**Built Heritage Sub-Committee / Sous-comité du patrimoine bâti**

Item Title / Titre du point de l'ordre du jour : Application to alter 70 Richmond Road, a property designated under Part IV of the *Ontario Heritage Act*

**Re / Objet : Technical amendment to replace Document 7**

**THEREFORE BE IT RESOLVED THAT the report ACS2022-PIE-RHU-0017 be amended by replacing Document 7 – Conservation Plan with the version dated April 30, 2022, a copy of which is on file with the City Clerk.**

*Figure 3: Plan view illustrating the temporary location for storing the Service Station across from the Richmond Road site.*

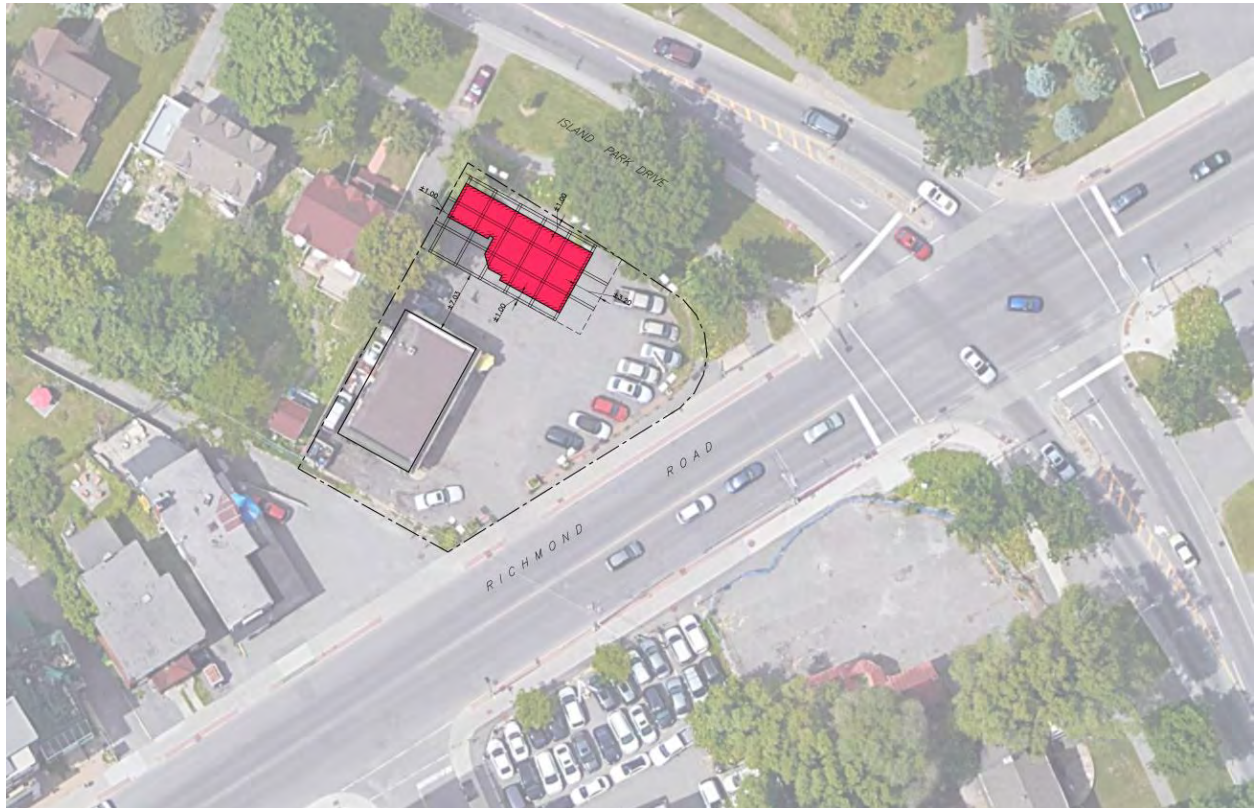
**WHEREAS the revised Document 7, dated April 30, 2022, reflects the new interim location for the building; and**
